## DS-K1T671 Series MinMoe Terminal Release Notes (2022-09-30)

<b>Device Model:</b> DS-K1T671M/MF DS-K1T671TMW/TMFW  <b>Naming Rule:</b> M for M1 card, W for WIFI, F for fingerprint	Firmware Version	ARM: ACS_671_AI3_EN_STD_V3.2.30_build220913 ACS_671_AI3_EN_NEU_V3.2.30_build220913
	Software Version	<b>HikCentral AC:</b> <a href="https://www.hikvision.com/en/support/download/software/hikcentral-access-control-v1-3-0/">https://www.hikvision.com/en/support/download/software/hikcentral-access-control-v1-3-0/</a> <b>iVMS:</b> <a href="https://www.hikvision.com/en/support/download/software/ivms4200-series/">https://www.hikvision.com/en/support/download/software/ivms4200-series/</a>

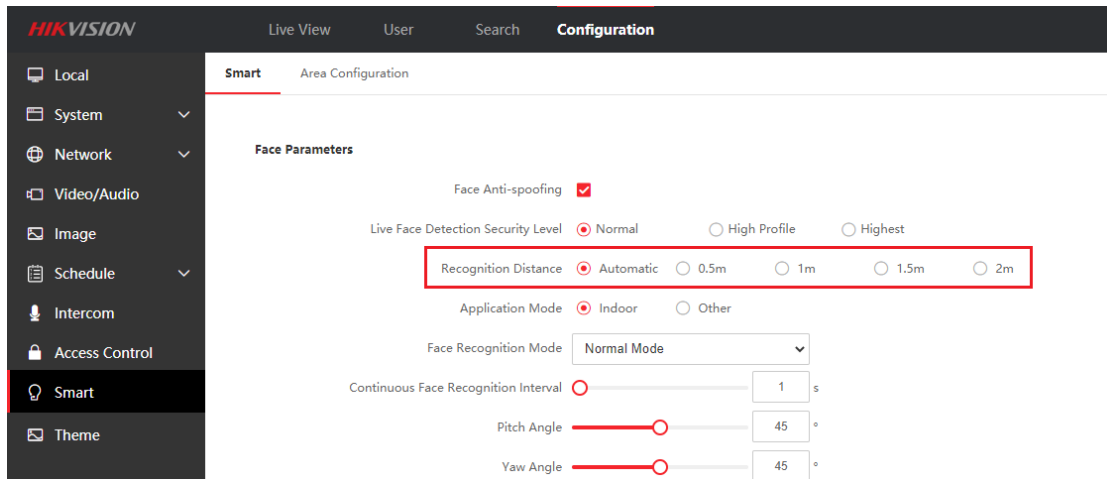
1. Optimize the wake-up distance of the device screen through the face, and the wake-up distance is consistent with the recognition distance

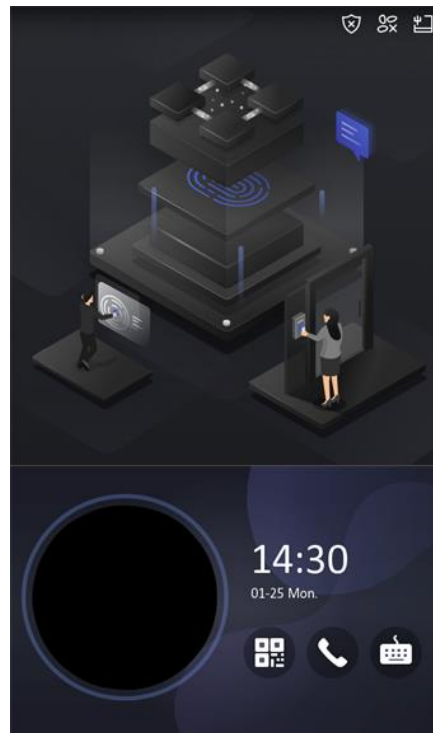
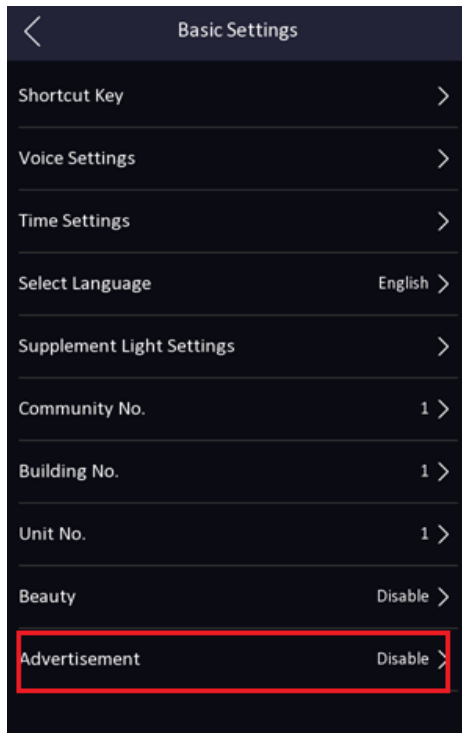
2. Support English, Spanish (South American), Arabic, Thai, Indonesian, Russian, Vietnamese, **Brazilian Portuguese**
3. Add Hik-ProConnect platform docking
4. Add advertisement mode, after enable, the wallpaper will be fixed to be displayed on the top of main interface.

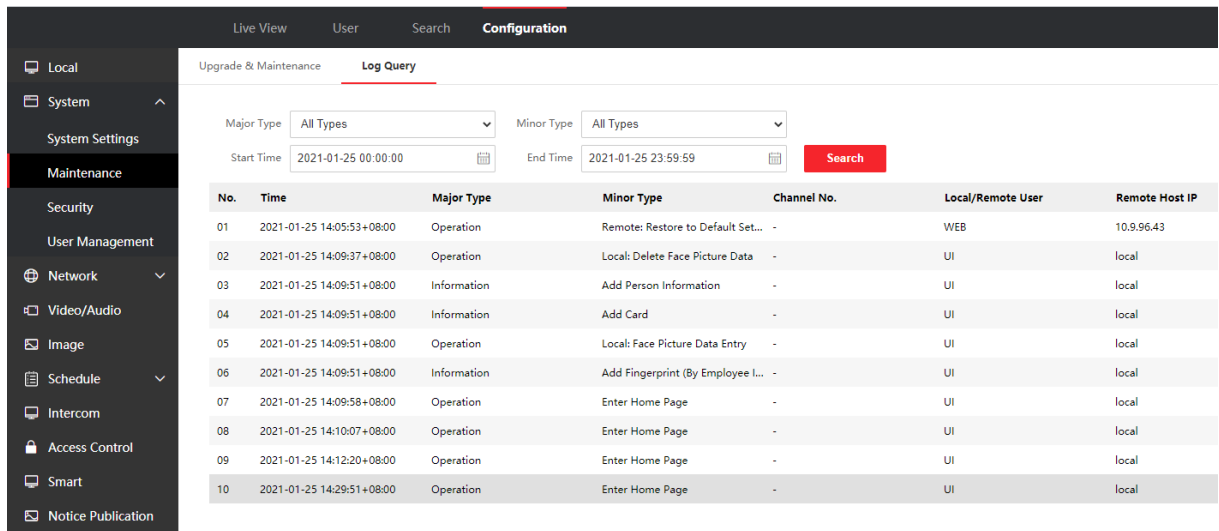
5. Add device operation log query function

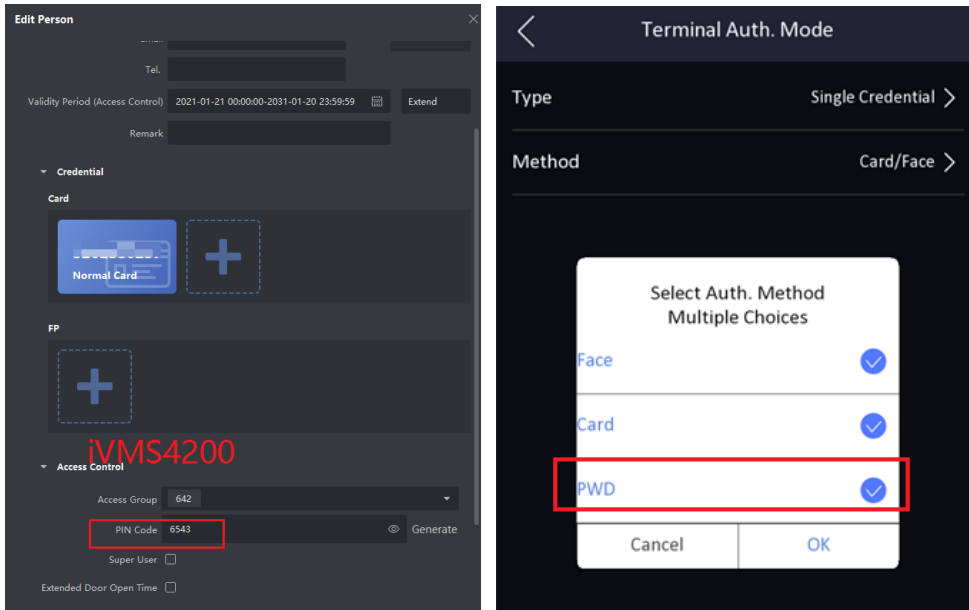
7. Support PIN code to open the door (disabled in default)

**Note:** PIN code should be configured from software, iVMS4200 already support, HikCentral Pro will support PIN code configuration in V2.1 expected to be released in June

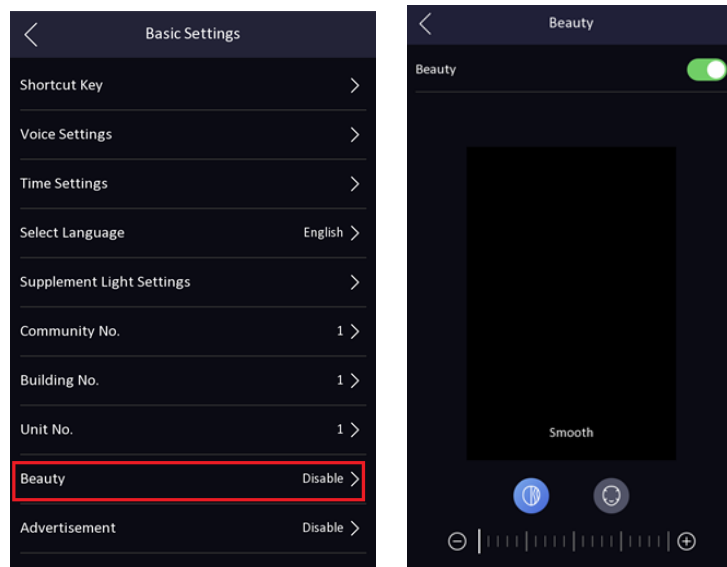
9. Add beauty function to adjust smooth and whiten parameter.

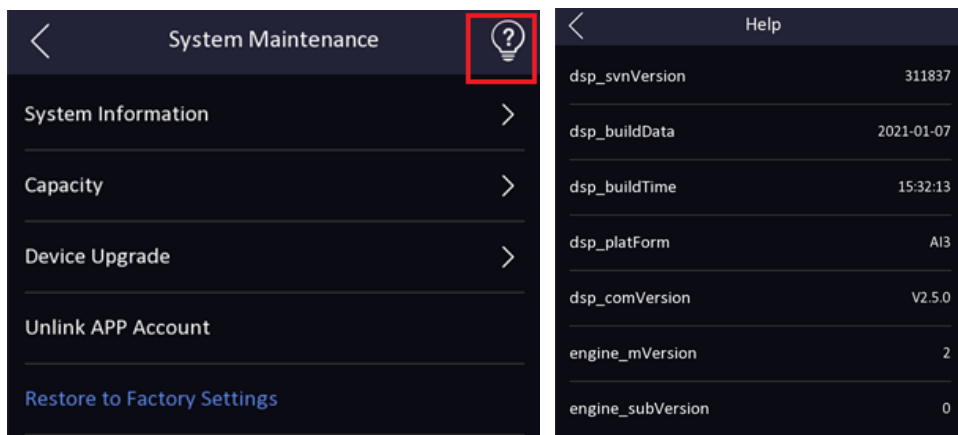
10. Add help interface to check system module version for technical support (long press for 3s).

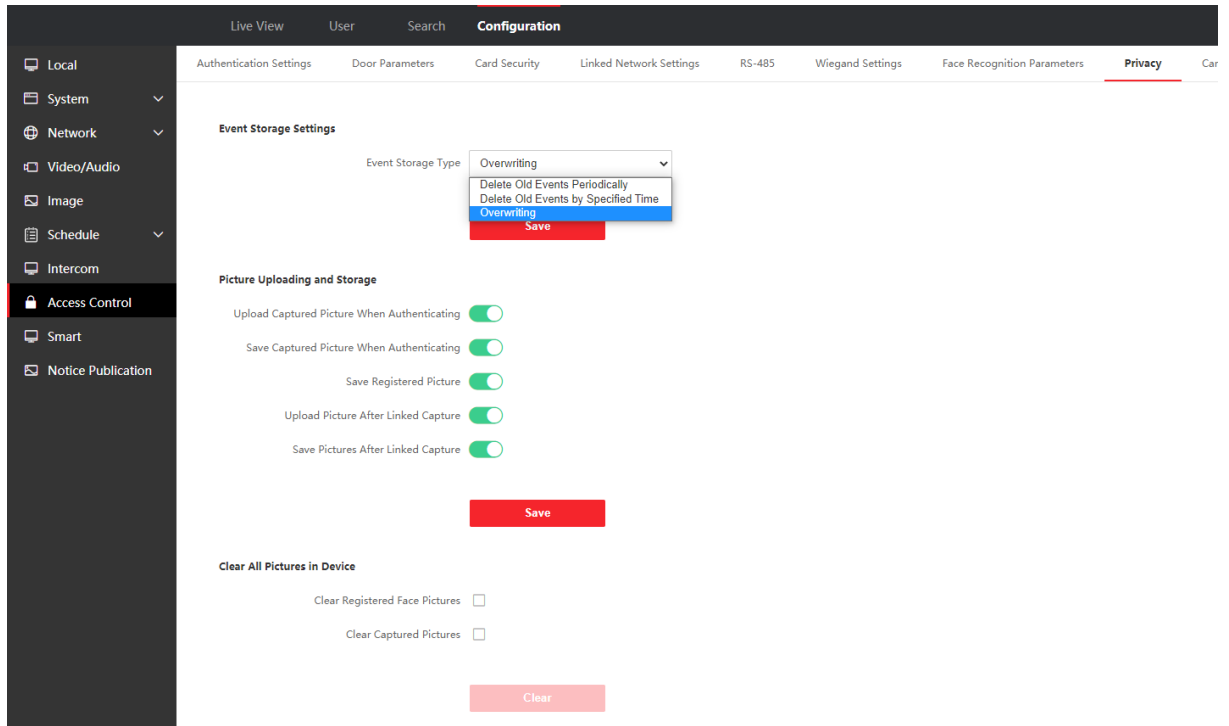
11. Add privacy protection, customer can define the privacy related parameter, such as Event Storage Settings, Picture Uploading and Storage, Clear All Pictures in Device

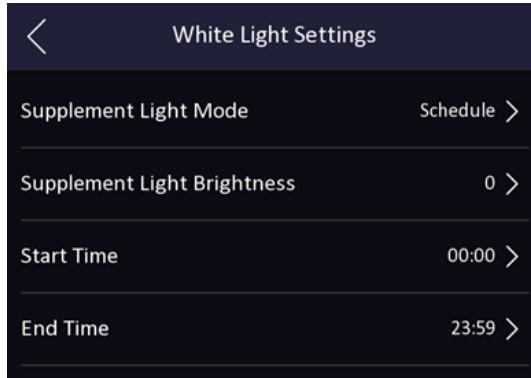
12. Configure the time period when the white light fill light is turned on and off in device local menu or web interface

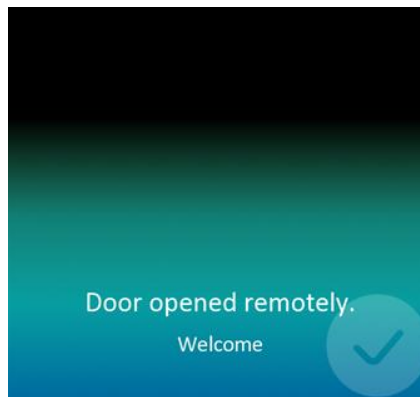
13. Add audio prompt 'The door is open' when open door on iVMS4200, HikCentral Pro, Hik-Connect App, and device UI will show prompt

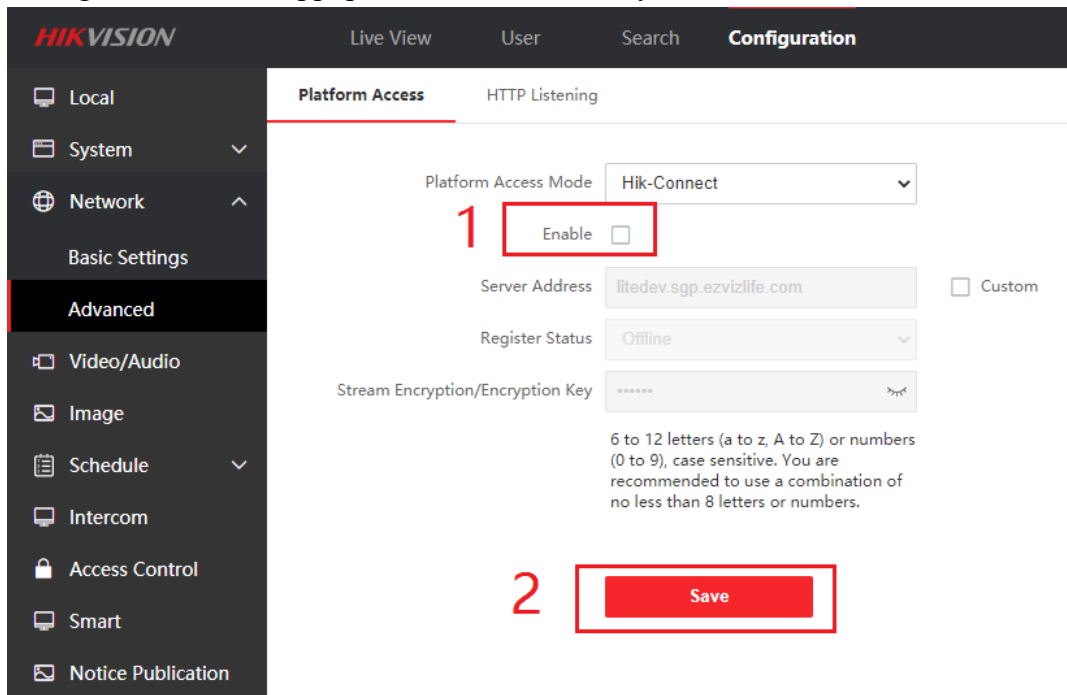
4. Hik-Connect function is turned off in default for privacy protection, if customer want to manage device from App, please turn on manually in the web.

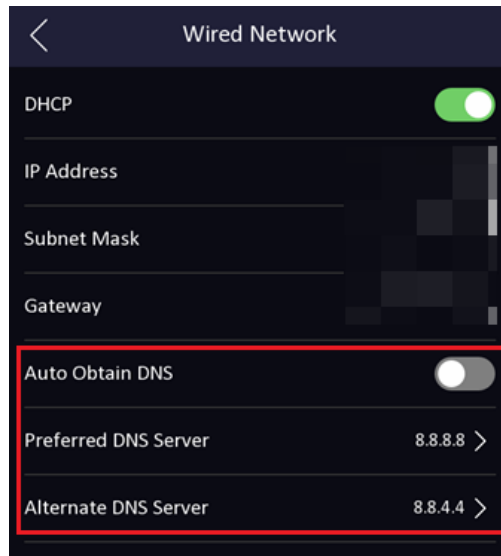
- 5. The face matching algorithm is upgraded. Improve the speed and accuracy of face recognition. Improved the recognition effect of dark masks
- 6. DNS can be configured from device UI in menu → Comm.-->Wired Network

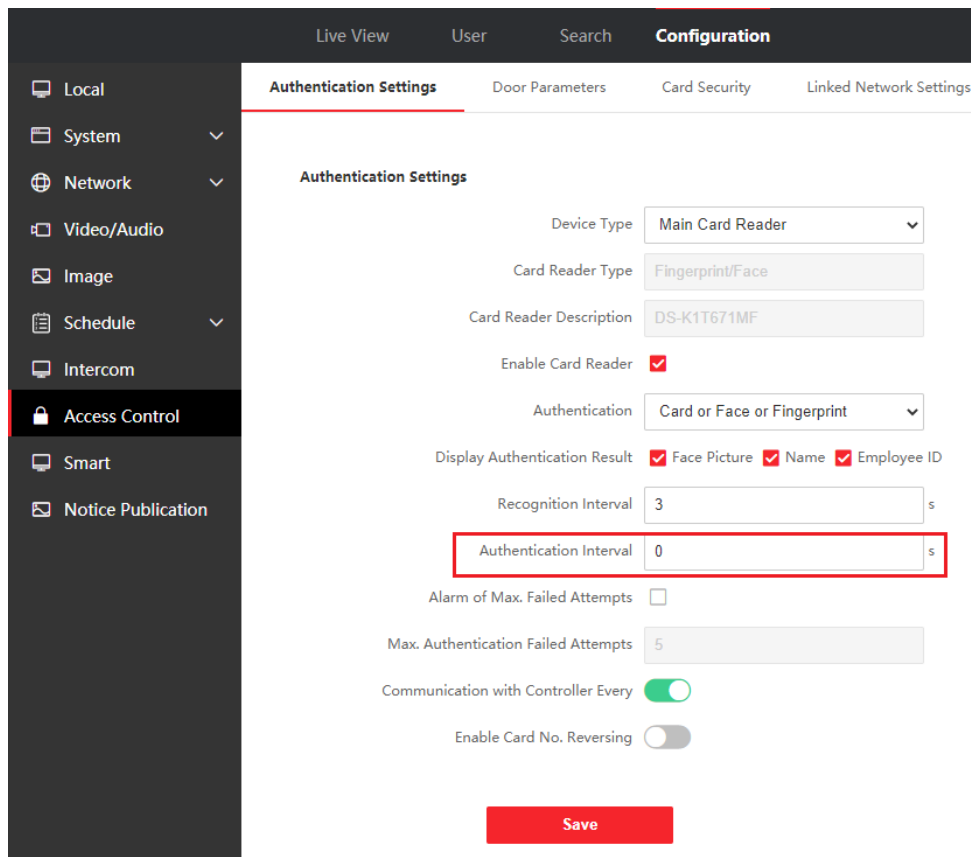
- 7. Optimized the ISUP and Hik-Connect event upload mechanism.
- 8. Add stranger authentication timeout time configuration

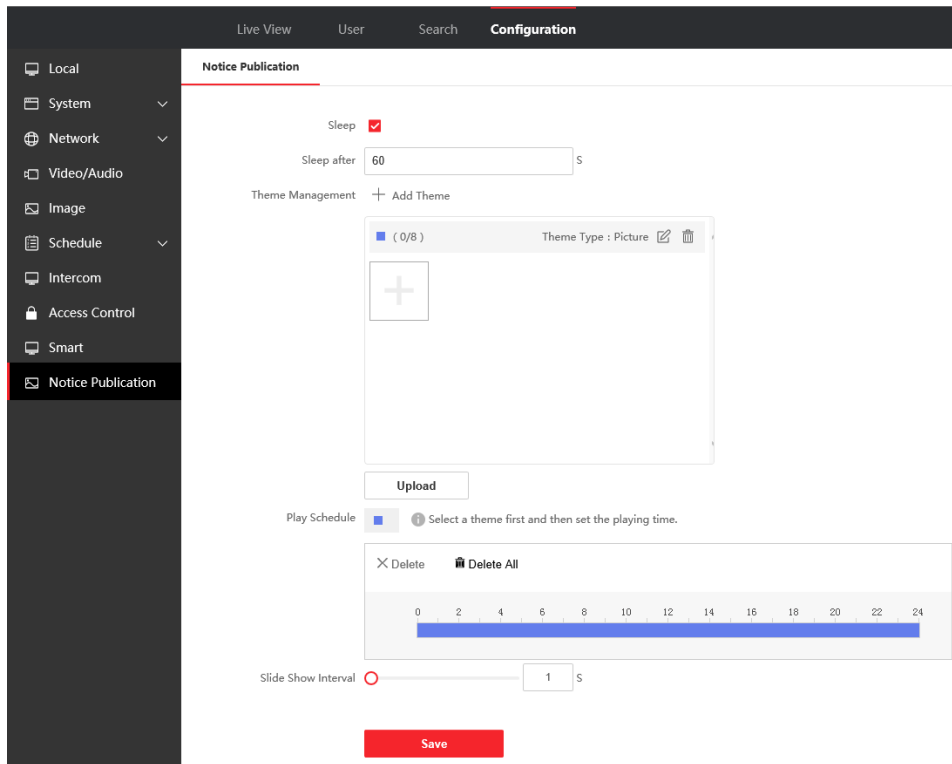
- 9. Add advertisement/wallpaper play schedule configuration, slide show interval.
